**SUBDIVISION COMMITTEE
METROPOLITAN AREA PLANNING COMMISSION**

February 19, 1998

**STAFF REPORT
(One-Step Final Plat)**

- CASE NUMBER:** S/D 98-9 - JOHNSON'S GARDEN CENTER RIDGE
- OWNER/APPLICANT:** Johnson Ltd. Joint Venture, 2707 West 13th Street North, Wichita, KS 67203

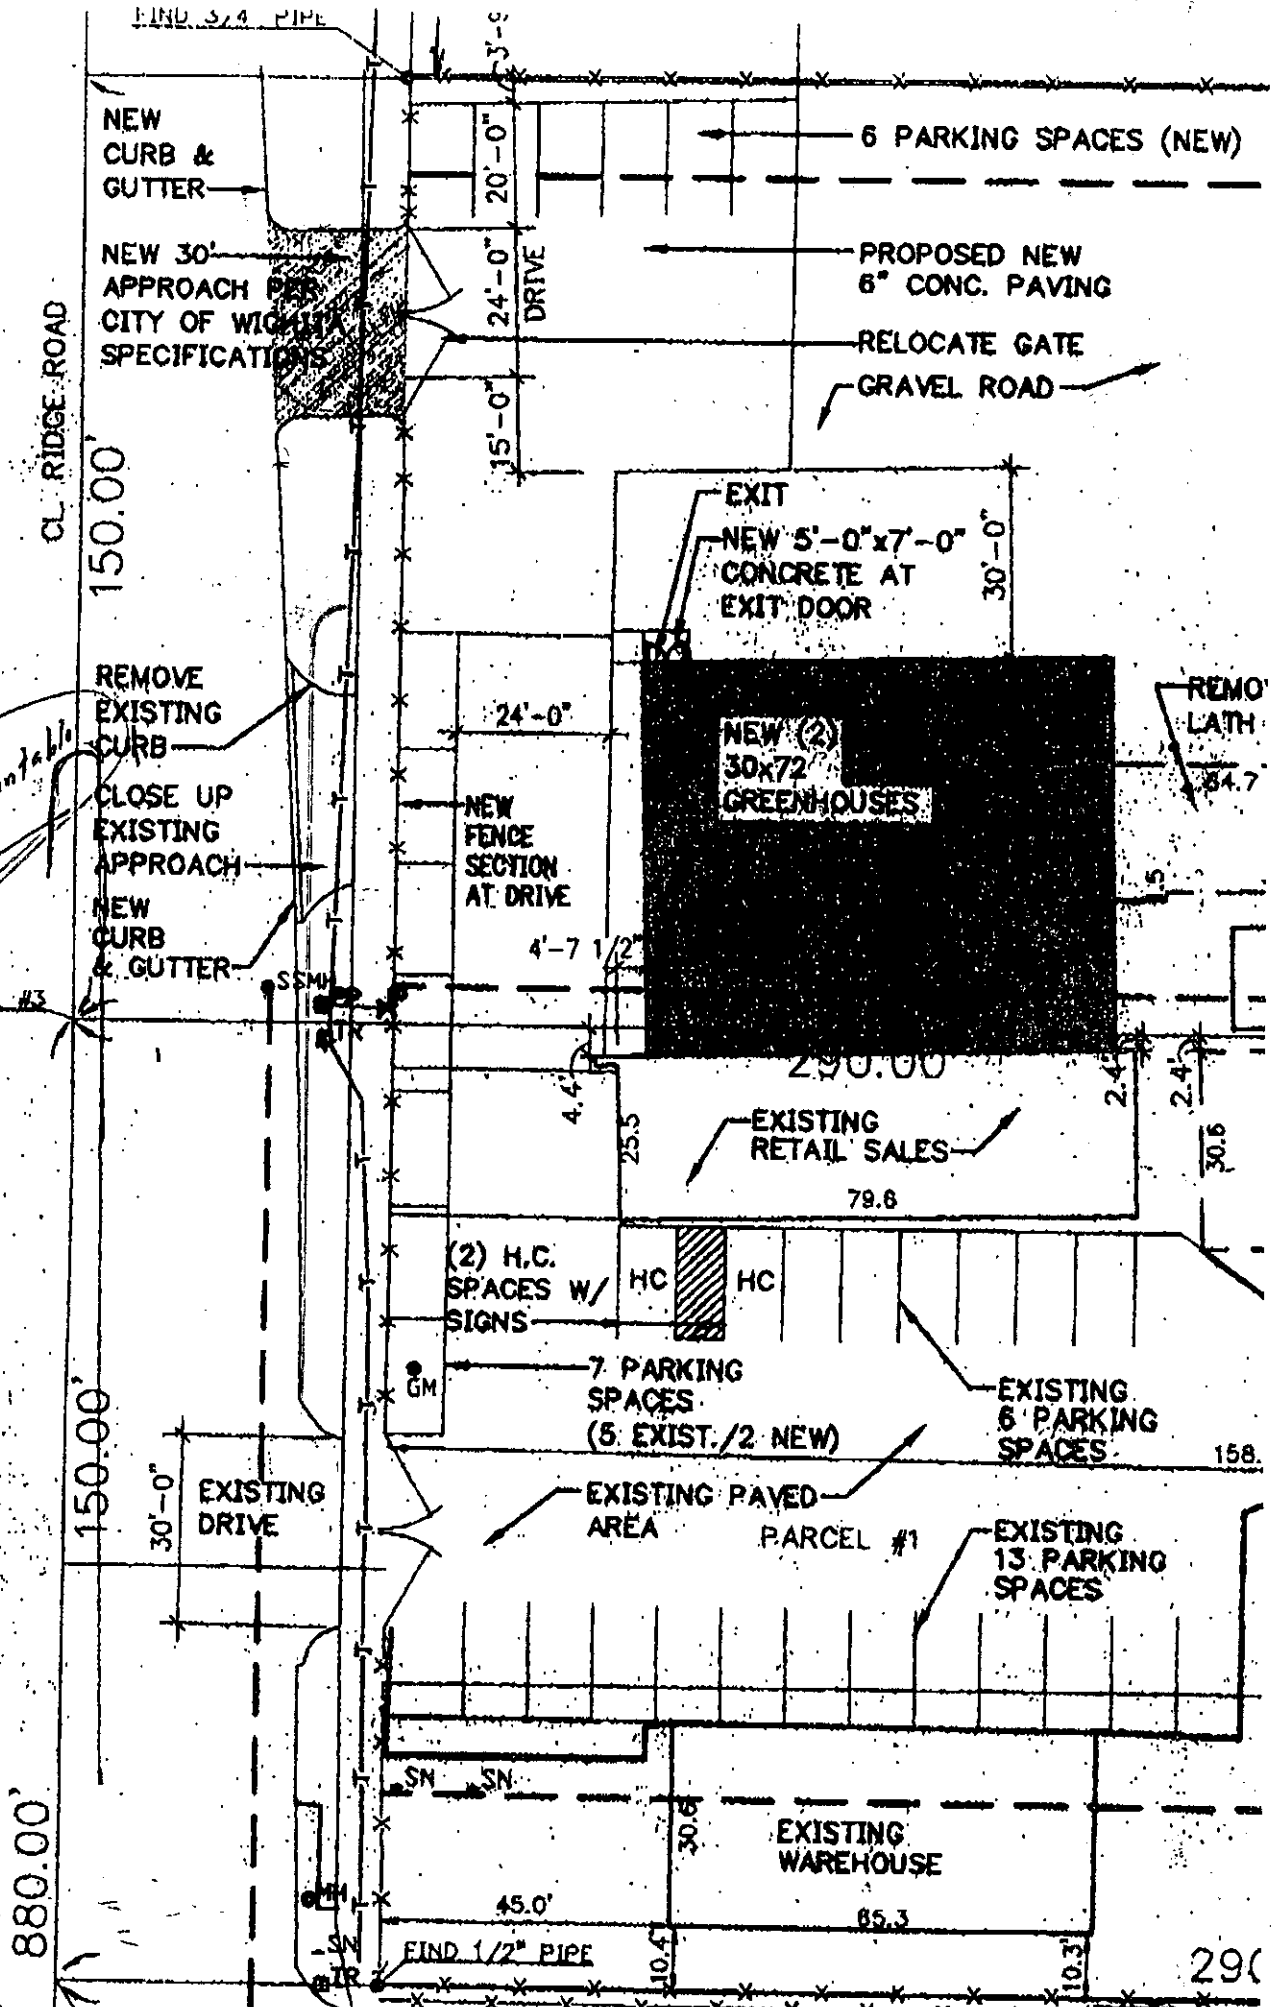
Mikel advised me
to advise Greg
to do what he
thinks is right:

T advised Greg

Existing Median Mountable
